Service Bulletin

Bulletin No.: PI0776B

Subject: Left Front Fender Liner Rattle, Ticking or Flutter Noise While Driving

Models: 2012-2013 Chevrolet Impala
2014 Chevrolet Impala Limited (VIN W)

2891248

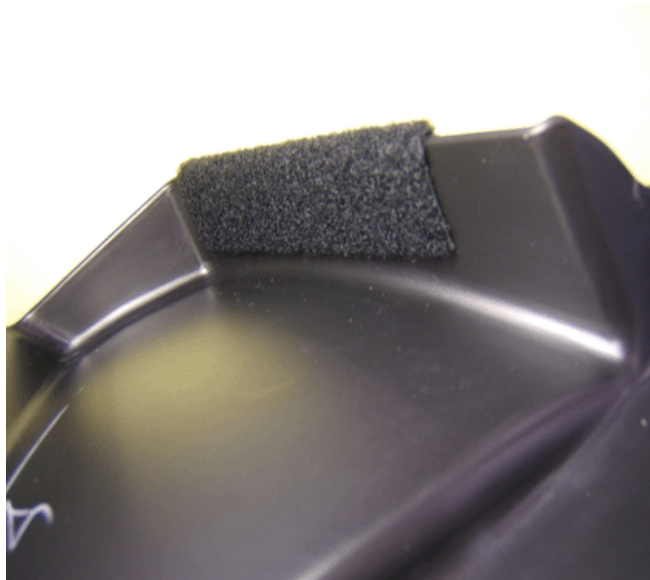
Some customers may comment on a noise coming from the left front of the vehicle while driving at speeds above 65 km/h (40 mph). This condition may be described as a rattle, flutter or ticking type noise.

This noise may be caused by the left front plastic fender liner (splash shield) making contact with the body structure.

Use the following steps to install isolating material on the fender liner that will prevent hard contact between the two components.

2891250

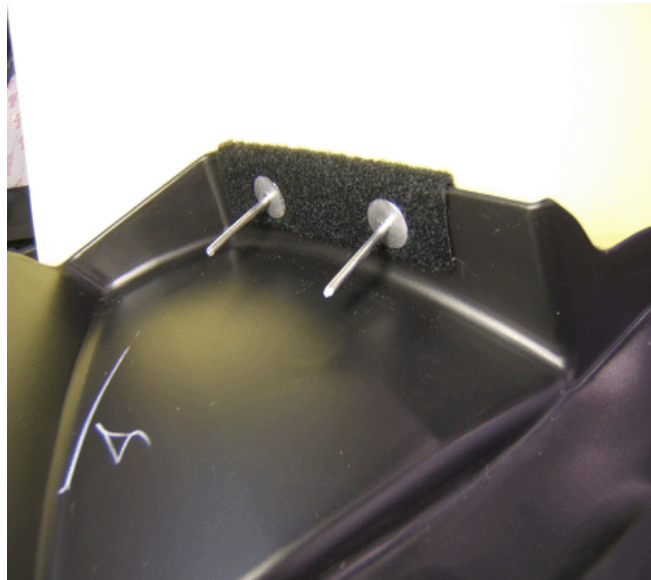
2. With the liner removed from the vehicle, locate the area on the liner shown.
3. Clean the repair area with a general purpose adhesive cleaner.
4. Using 50 mm (2.0 in) wide hook and loop fastener material (soft "loop" side) such as "Velcro Brand Loop 1000 2.0," prepare two pieces 200 mm (4 in) long.
5. Layer the two pieces of material.

6. Fold the material length wise and install to the fender liner as shown.
